Our ref: TC/T19360/2021/02

Date: 24 November 2021

Re: Exceedance Routing at Waters Edge, Whitehaven (Gleeson Homes Development)

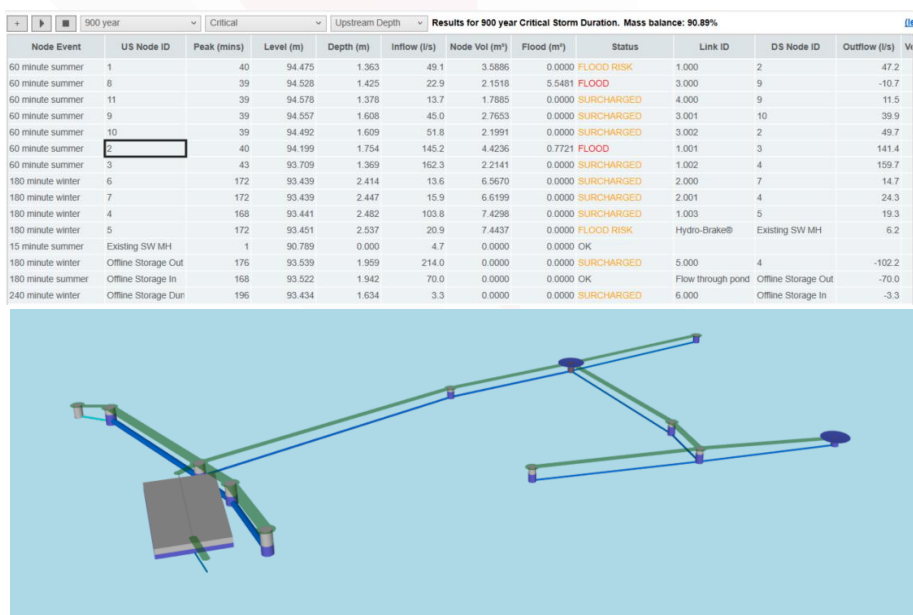
Below is an extract of the Causeway Flow model for the site. The calculations represent a 1 in 900-year return period of critical duration. The first possibility of flooding occurs in the 1 in 600-year return period above and beyond the design requirement outlined by Cumbria County Council (CCC). Even in the 1 in 600-year return period a maximum of 0.03m³ of flooding would occur from manhole S8. The highway (based on a 4m x 4m area and 0.1m kerb catchment) would provide 1.6m³ of storage to contain the flood before it could start to encroach the footpaths. The buildings FLL's are all raised again above this.
